1 ADDENDUM 1: DATE: 10-16-07

MD 355 (ROCKVILLE PIKE) AND TWINBROOK PARKWAY / ROLLINS AVENUE

INTERCONNECT PLAN

TS NO. 1077A | DRAWING NO. 3 OF 3 | SHEET NO. 10 OF 42

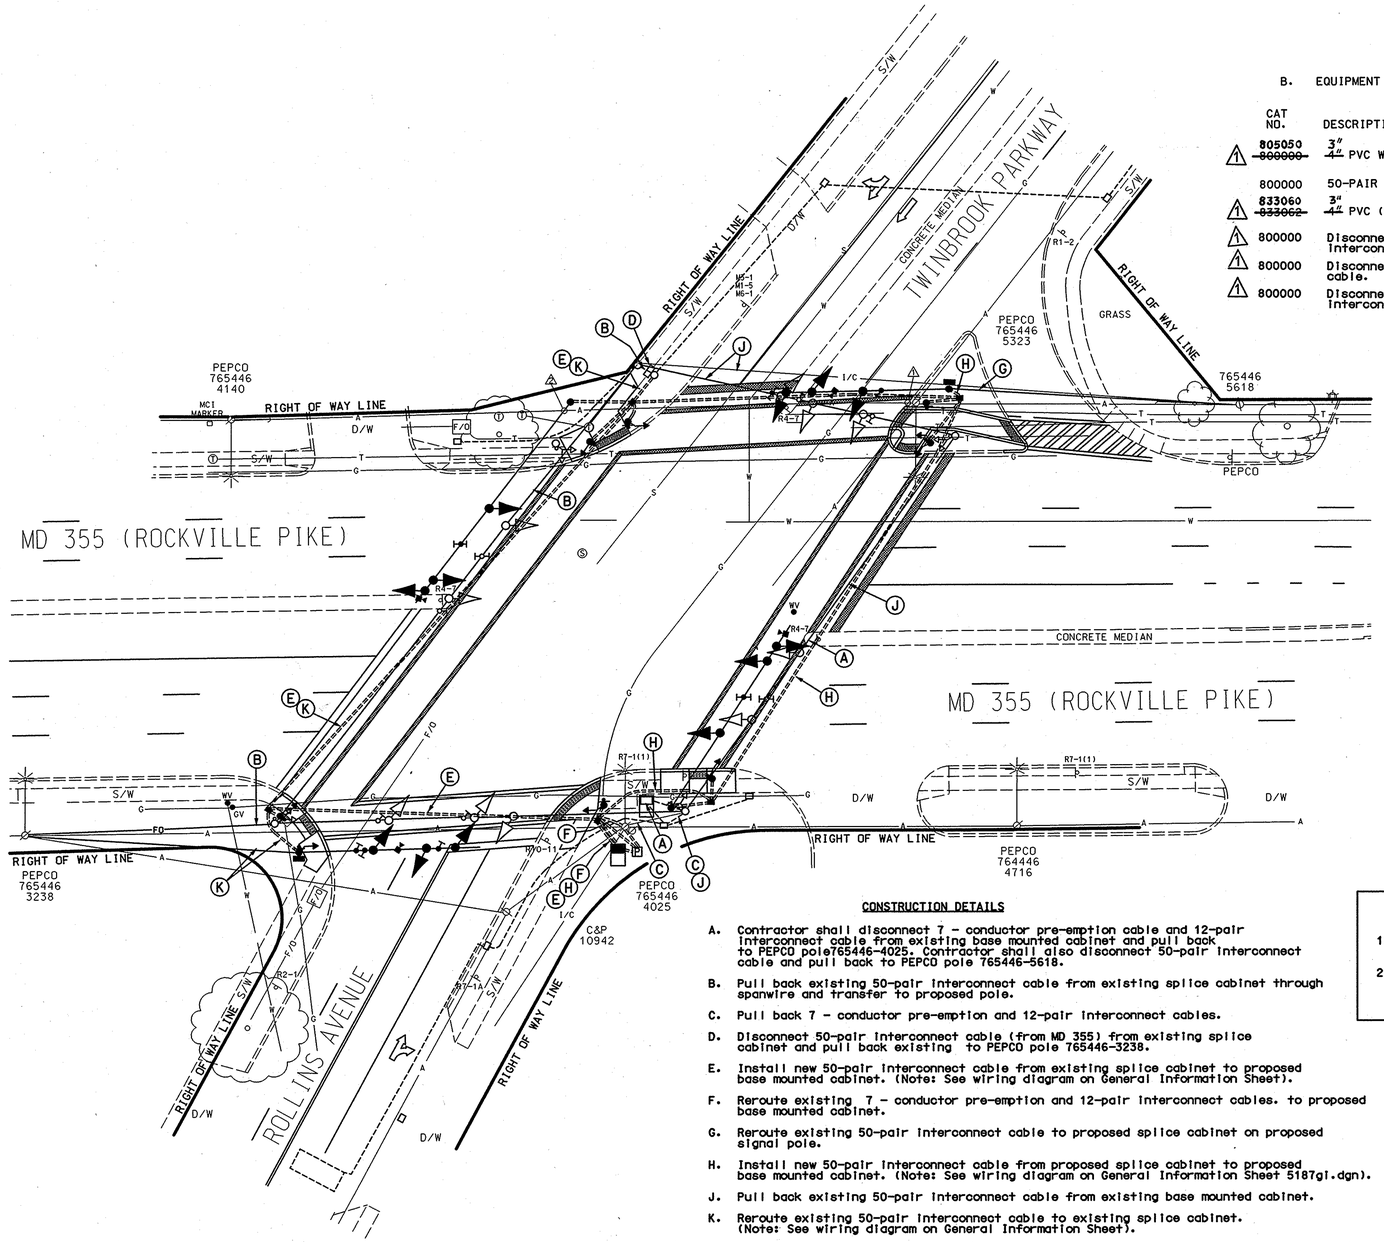
CAT NO.	DESCRIPTION	QUANTITY
1 805050 ~~800000~~	3" ~~4"~~ PVC WEATHERHEAD	3 EA
800000	50-PAIR INTERCONNECT CABLE (UNDERGROUND)	500 LF
1 833060 ~~833062~~	3" ~~4"~~ PVC (SCHEDULE 80) RISER	105 LF
1 800000	Disconnect, pullback and reroute 12 pair interconnect cable.	200 LF
1 800000	Disconnect, pullback and reroute 7-conductor cable.	200 LF
1 800000	Disconnect, pullback and reroute 50 pair interconnect cable.	1200 LF
